Re: Target Riverdale Plaza Precast Panel Failure
WJE No. PC09.1981

At the request of Faegre & Benson LLP and Target Corporation, WJE Engineers & Architects, P.C. (WJE) has performed a limited investigation to opine on the cause of the precast panel connection failures at the Target store T1798 located in Bronx, NY. This letter serves as our report on this matter.

Figure 8- Typical Connection "Type 62"

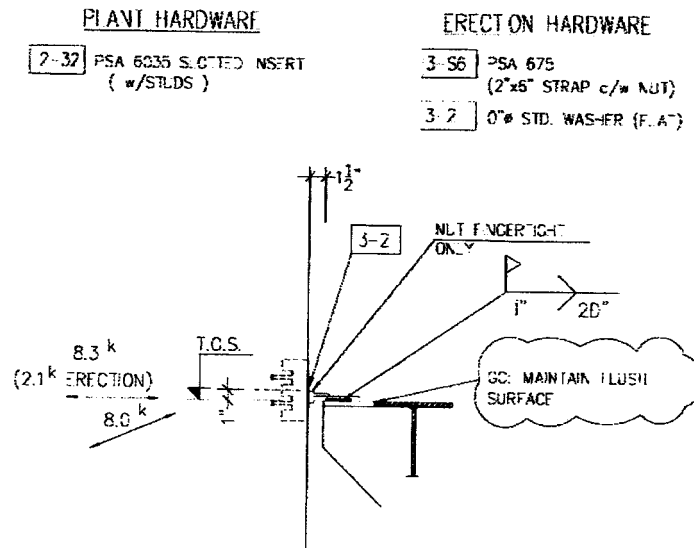
Connection "type 62" is a slotted insert connection that is cast into the back of the precast panel. It is manufactured by PSA. To provide a lateral connection back to the steel frame, a threaded rod/weld plate is welded to the top flange of the steel spandrel beam and attached to the insert by a nut behind the slot (Figure 8).

Figure 10- Detail 3/S-8 from GFA Documents

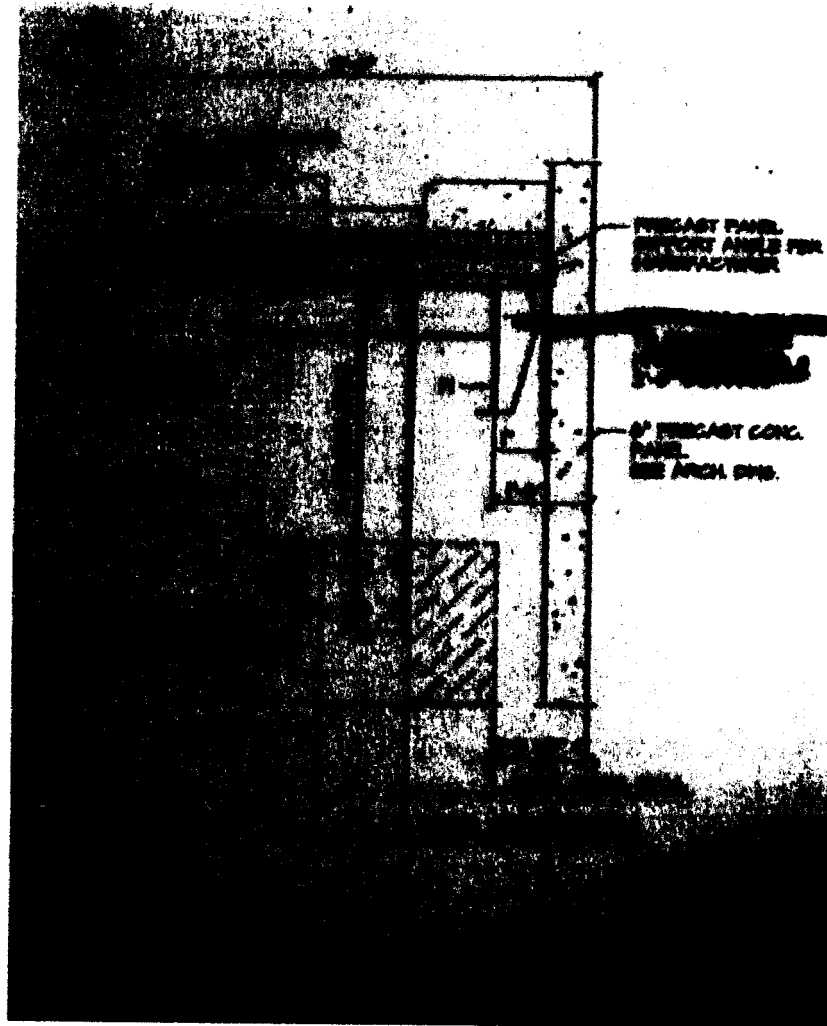
WJE reviewed GFA's bulletin 4 drawings dated October 9, 2002 for details pertaining to the roof slab and precast panel connections. The roof slab consists of a 5 ¼ in. lightweight concrete slab on top of a composite 2 in. deep, 18 gauge steel deck. The typical structural detail for the slab/precast wall panel interface is shown in detail 3/S-8 (Figure 10). In this detail, a 1 in. gap is shown between the edge of the structural slab and the face of the precast panel. No details for the roof buildup or topping slab are included in the structural drawings.

Figure 21- As Built Roof Build-Up

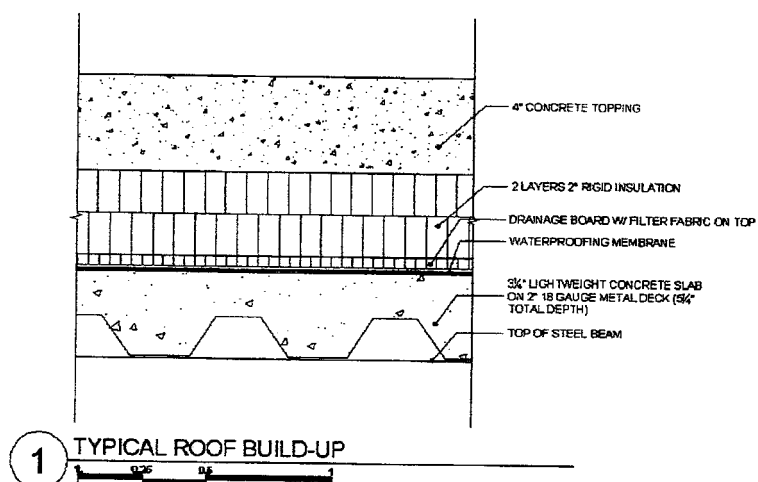
followed by two layers of 2 in. rigid insulation (4 in. total) followed by 4 in. concrete topping slab and 6 in. curb at the edges (Figure 21). At the northeast corner, WJE observed a location where an opening in the topping slab and curb was made adjacent to a section of curb/slab remaining in place. The section remaining in place could be viewed from the side (Figure 22). An approximate 1 1/2 in. gap was observed between the edge of the structural slab and the face of the precast panel. The waterproofing membrane turned up the face of the precast panel approximately 1 ft. as shown in the design drawings and terminated with a termination bar. The filter fabric and drainage mat terminated at the precast panel and did not turn up the wall (Figure 23). The construction largely comports with the architectural drawings except as follows: A drainage mat and filter fabric were used in lieu of the protection board shown in the drawings and two layers of Extruded Expanded Polystyrene rigid insulation (DOW blue board) were used. The concrete at the edges was cast up against the precast panels with a piece of fiberboard between the precast panel and edge of slab. The curb was then cast on top of the topping slab as opposed to being cast monolithically next to the edge of the topping slab as shown in the drawings. Also, the steel curb edge specified in the drawings was not installed.

From this view, WJE observed that there was no gap cast between the edge of the topping slab/curb and face of the precast panel. Only the waterproofing membrane and an approximately 1/2 in. thick piece of fiberboard separated the slab edge from the precast panel face. Furthermore, a lateral displacement between the two layers of rigid insulation was observed.

Figure 28- Typical Precast Panel to Panel Connection

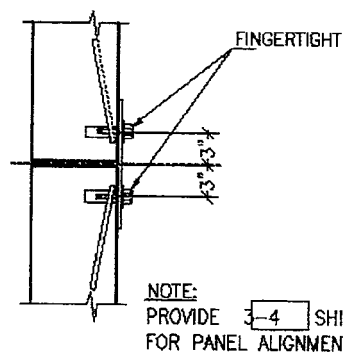
TT acknowledges that panels in corners cannot be impacted by snowplows. The TT report postulates that the failed connections of precast panels that are protected from a direct impact are the result of the impact forces of adjacent panels being transferred through the inter-panel connections. The inter panel connection shown in Figure 28 consist of a plate crossing the panel joint with a single bolt on either edge of the panel. The tensile capacity of this bolted panel edge connection is about 4000 lbs, which is less than that of the lateral panel insert connection (type 62). Therefore, the panel-to-panel connection will fail long before sufficient load is transferred to fail the slotted insert connection. Furthermore, if forces were being transferred from an impacted panel to an adjacent panel, twisting of the panels would be observed at the panel joints. WJE did not find observe any panels that appeared to be twisted or out of alignment relative to the panel directly adjacent to it.
